intel® Technical Advisory

TA-245-1

Some C440GX+ based servers may experience a system hang when add-in cards are installed in PCI slots 5 or 6

BOXC440GX, BC440GX

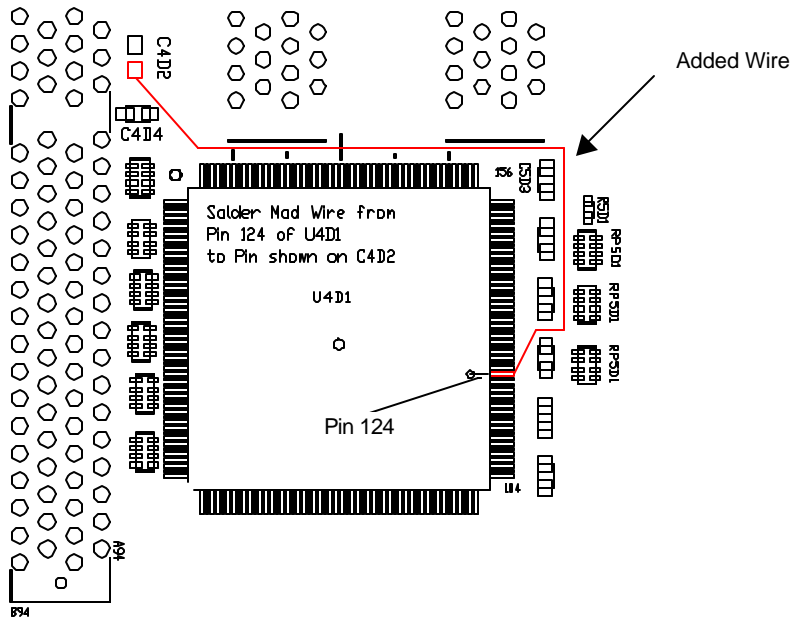
The Intel SPD Engineering team has developed a software fix for this issue and has incorporated it into a new System BIOS, version 6.0. Compensation circuits on the 440GX will be enabled through a buffer strength setting in the BIOS to reduce the effect of the edge rates to the 21150BC bridge chip. System BIOS 6.0 will be installed on all C440GX+ server boards in our factory, posted to IBL, and will be made available on Intel's Support web site at <http://support.intel.com>.

In addition, hardware changes will be made to the server board design to further decrease the possibility of failures. Intel manufacturing will be implementing a change, for all new shipments, by routing a 5volt signal to pin 124 of the 21150BC bridge chip.

- OEM C440GX+ server boards with BIOS 6.0 and the hardware change will be labeled with a PBA # of 726134-415.
- Boxed C440GX+ server boards with BIOS 6.0 and the hardware change will be labeled with AA# 727281-005.
